Hydro One Networks Inc.

Title:
SHORELINE PROTECTION OF CABLES - LIGHT DUTY

Drawing No.
DU3-301-0500

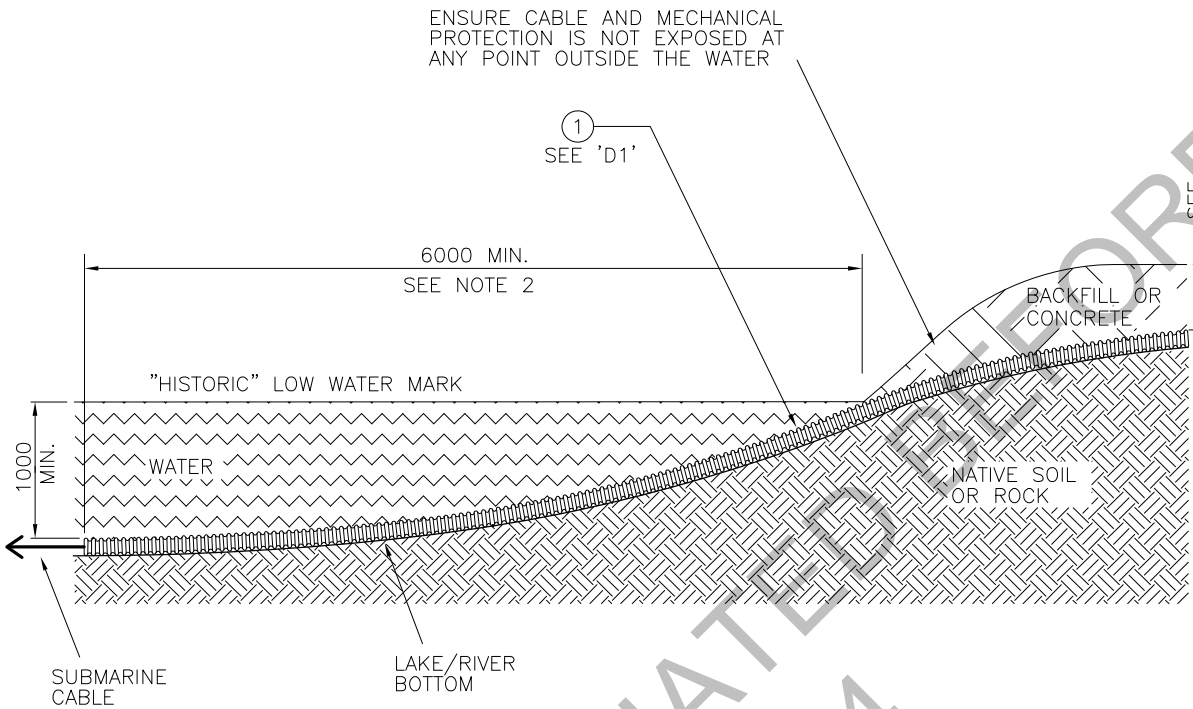
01	SEPT 2023	ORIGINAL DU-06-405.1-0500-R2 IS NOW SUPERSEDED BY THIS NEW DRAWING/REVISION. CHANGED TO SECTION 3. GENERAL UPDATES.	PC	MM	AS	MM
Rev No.	Date	Revision Particulars	dwn	ckd	des	app
